SOCAMES 6 Design Alert 1

HEFP SEP (SOCAMES 6) Design Alert 2

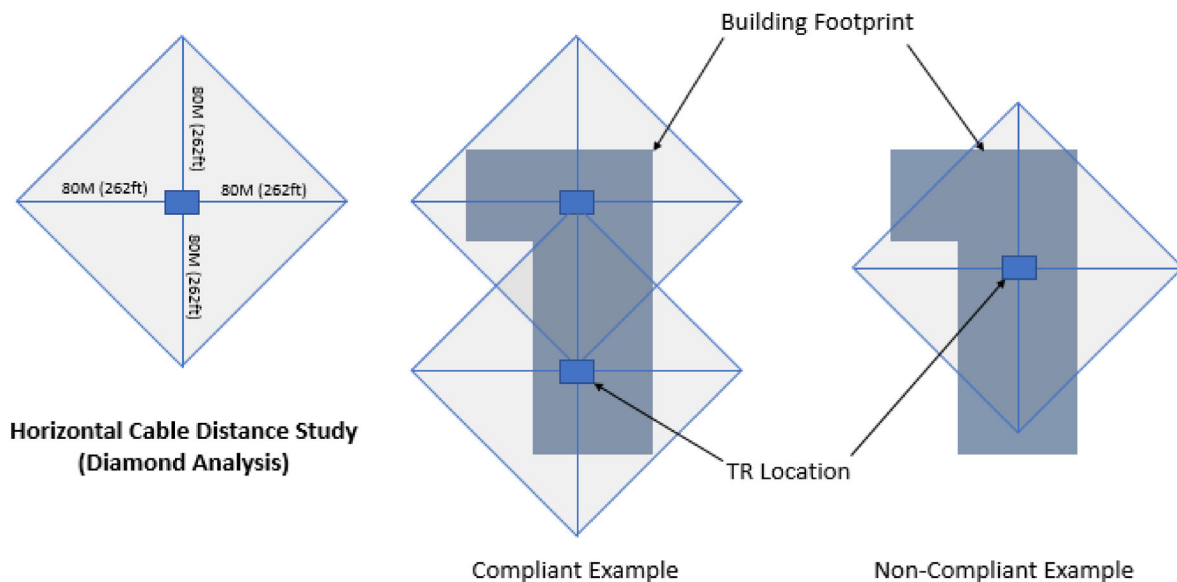
Step 2: Utilizing AutoCAD or rule, center on the location of the telecommunication room being assessed. From the center of the room project out lines, 80 meters in length from that point, in the plan north, south, east and west respectively.

Step 3: At the end each of the 80 meters lines created, connect a line 45 degrees from that point out to the next end point creating a diamond.

Step 4: Validate that all areas served by that telecommunication room fall within the parameters of the diamond overlay.

Below is a diagram of an example demonstrating the use of the estimation tool.

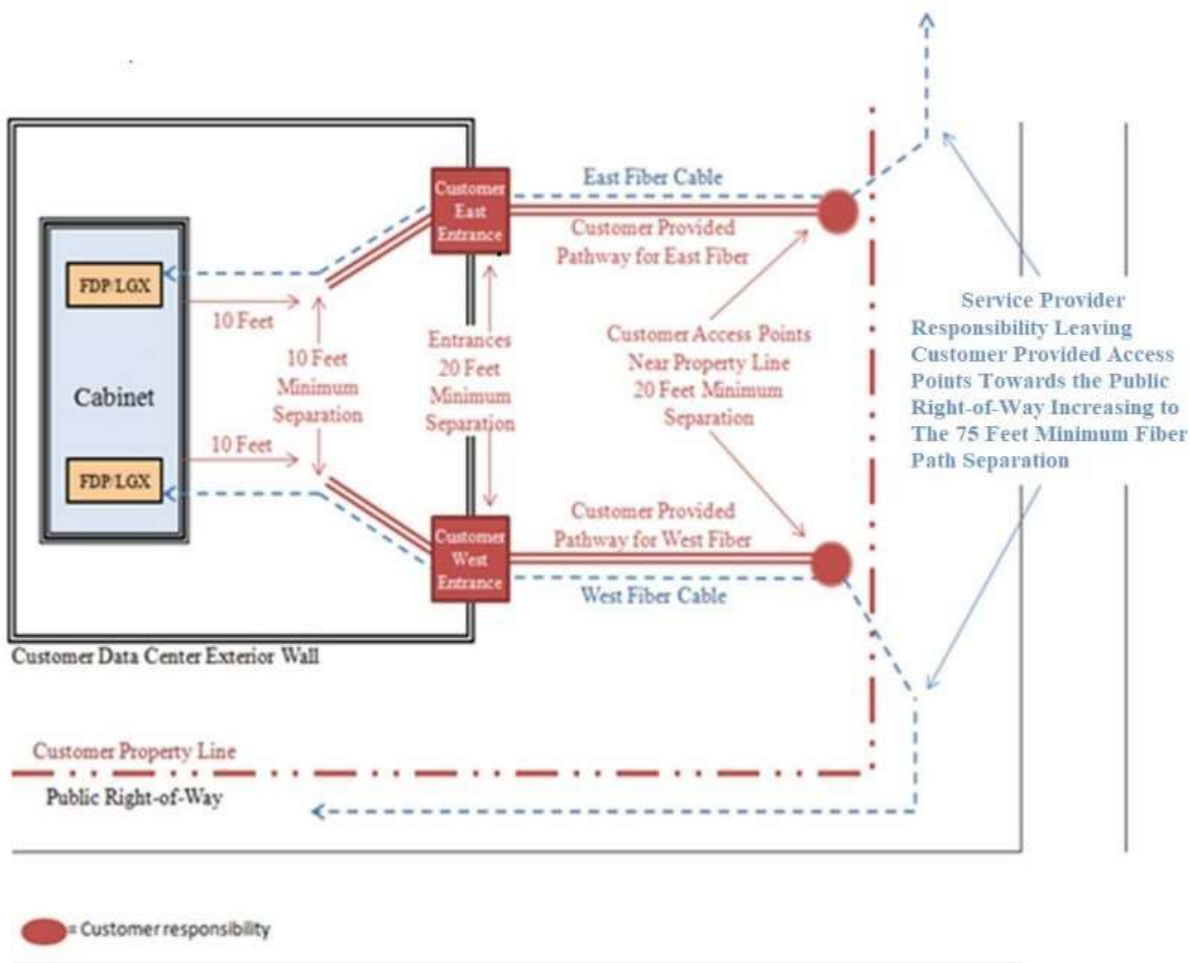
- B. Facility shall have end-to-end, geographically diverse and carrier-diverse circuits with minimum fiber pathways separation: service provider public rights-of-way 75 ft, Egress 20 ft, and cabinet 10 ft. See below Figure 1.
